**Delaware River Joint Toll Bridge Commission  
Request for Proposals  
Contract No. DB-724A  
Capital Project: 1801A  
Electronic Surveillance / Detection System (ESS)  
Maintenance Contract  
Addendum No. 1**

**ADDENDUM NO. 1**

CONTRACT NO. DB-724A

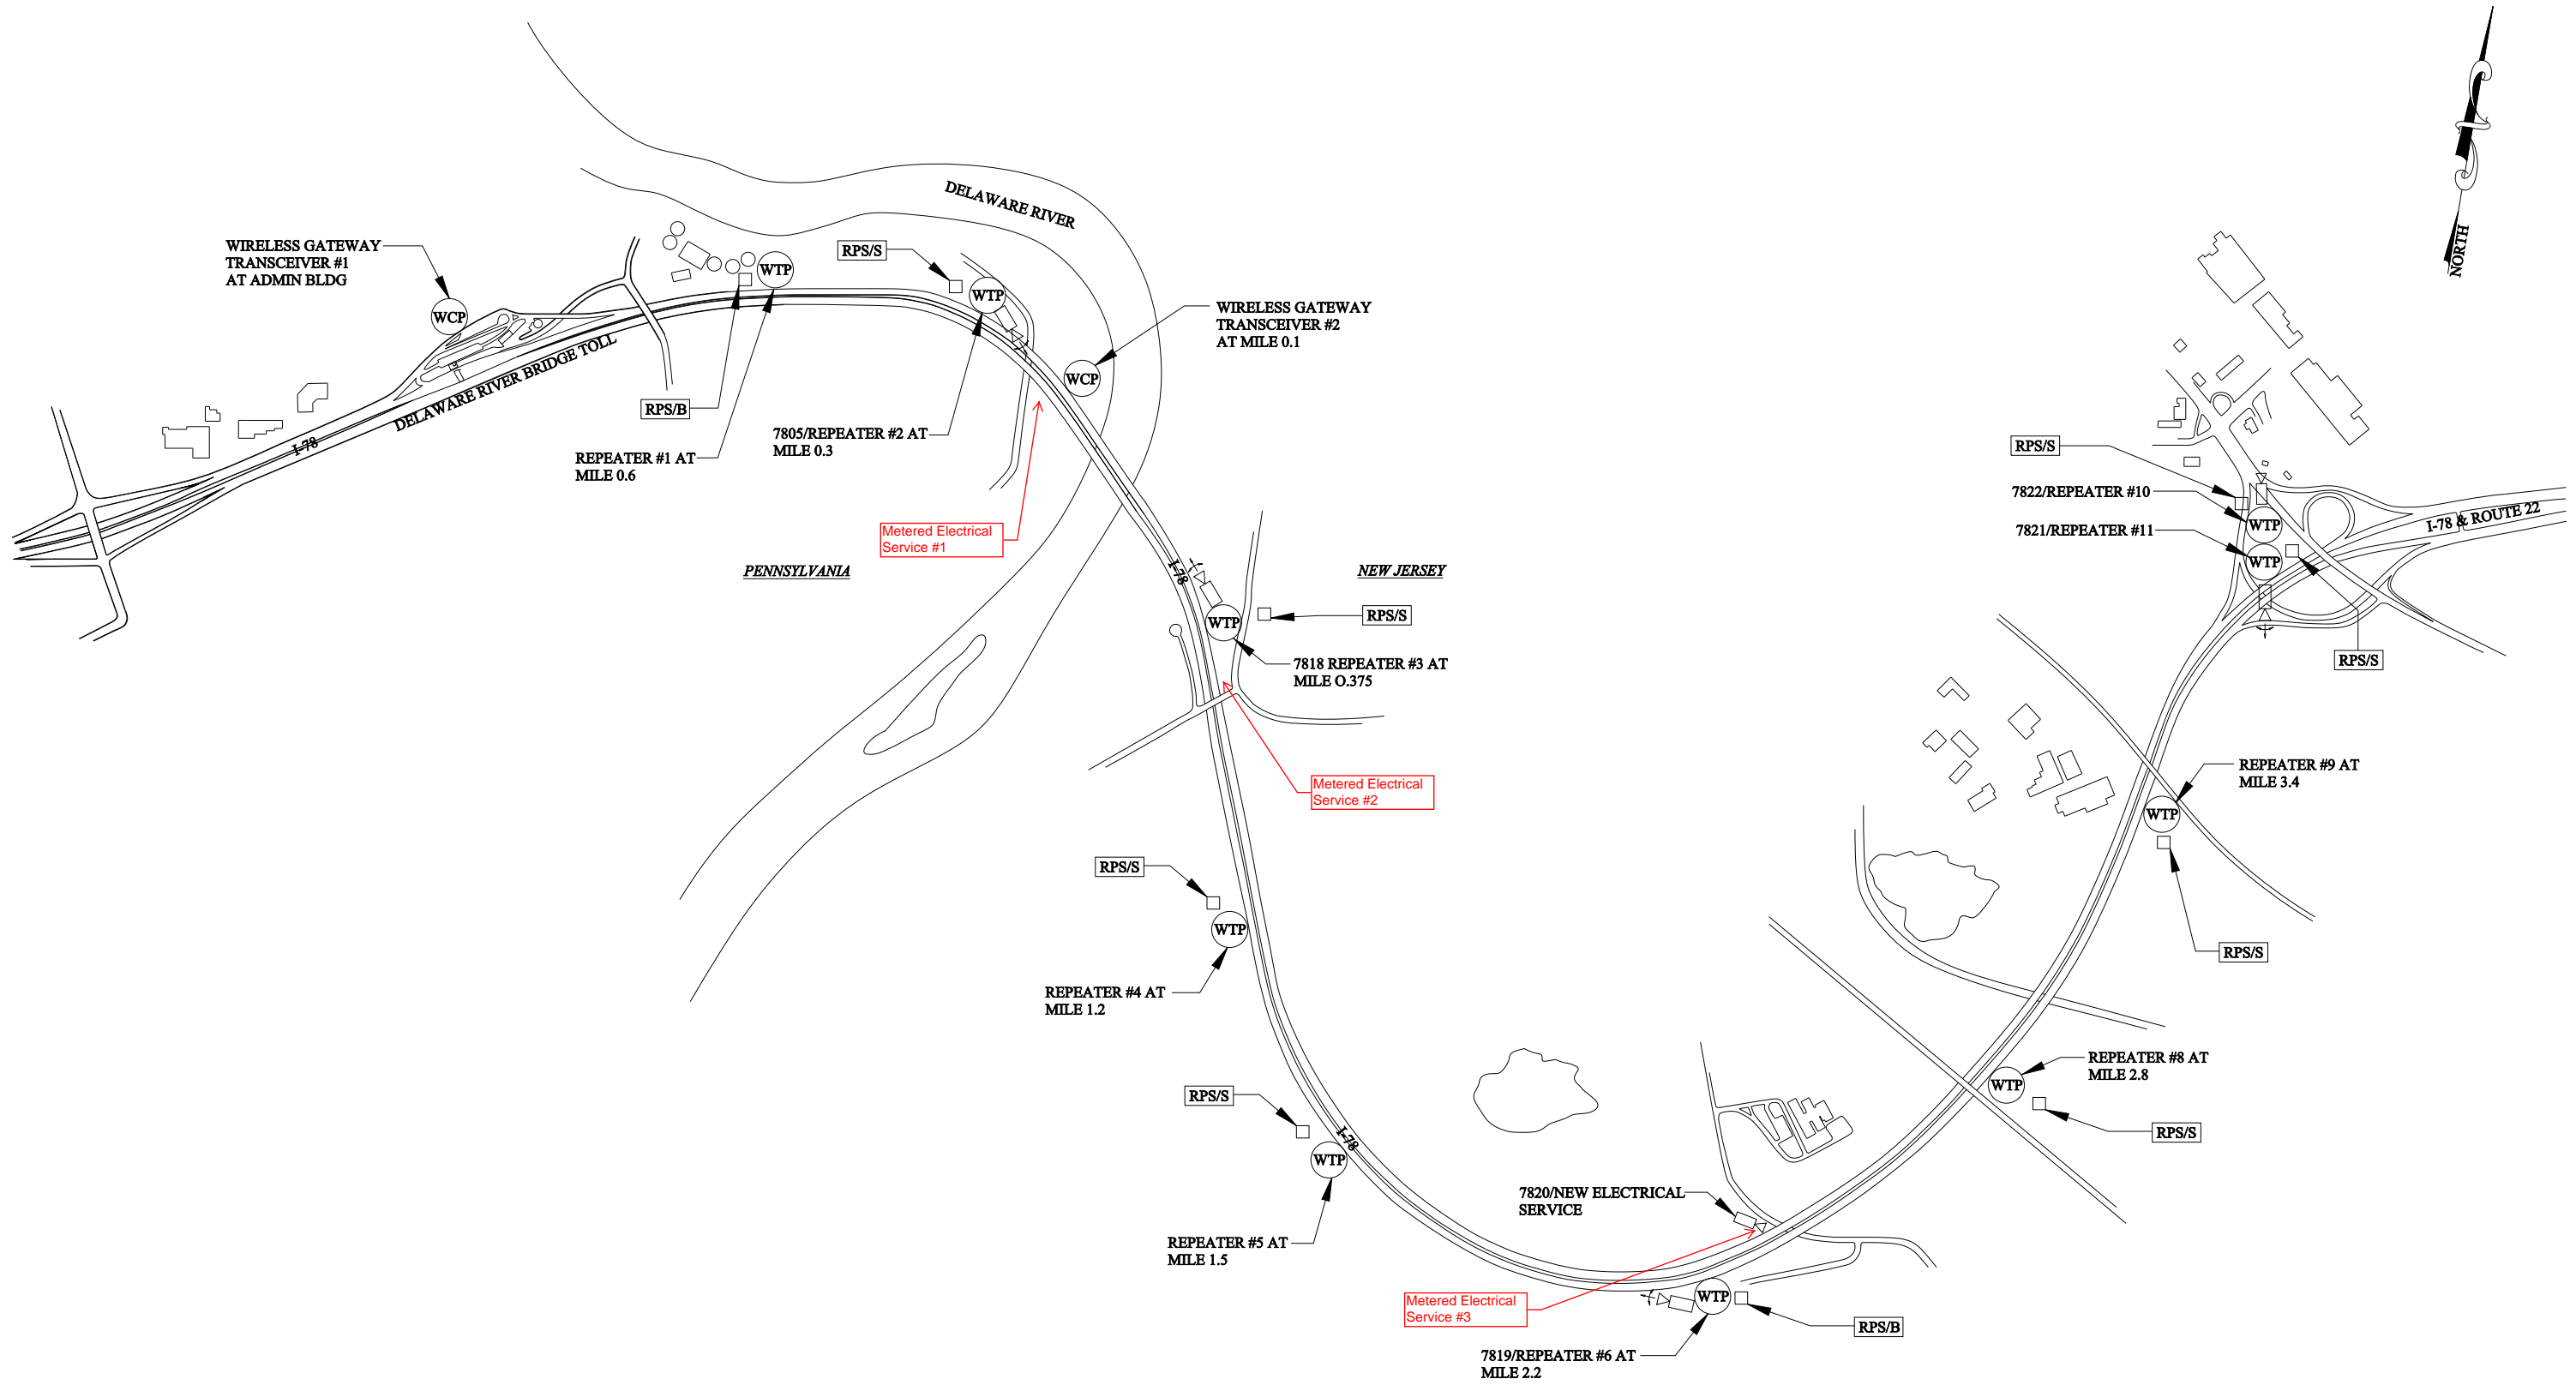
4. **Inquiry**: For Section 2.2.2.4, Phase 4 of the ESS enhancements, is it acceptable to connect new fiber and power cabling to the existing communication and power infrastructure at I78/611, instead of running the cable all the way back to the I78 administration building?

The ESS CONTRACTOR should note that the COMMISSION has three (3) metered services along I-78 which may serve as power junction points in addition to that which is available at the I-78 Administration Building. The plan sheet attached to this Addendum No. 1 illustrates the location of the metered service points. There may not be any unused capacity available or, if unused capacity exists, it may not be sufficient for the I-78 communications and power system enhancement. The ESS CONTRACTOR is responsible to 1) determine what unused capacity exists, 2) determine what capacity is required and 3) design/build the I-78 communications and power system enhancement accordingly. Any upgrades to existing metered services or installation of additional metered services will be the financial responsibility of the ESS CONTRACTOR; whereas, the operational cost of using the electrical service will be the responsibility of the COMMISSION.

**Response:** Power cabling is not required to run all the way back to the I-78 Administration Building; however, fiber optic cabling is to be continuous from end-to-end. The LAN reporting relationships between field devices and both the I-78 Administration Building and I78/611 sites are to remain as they currently exist.
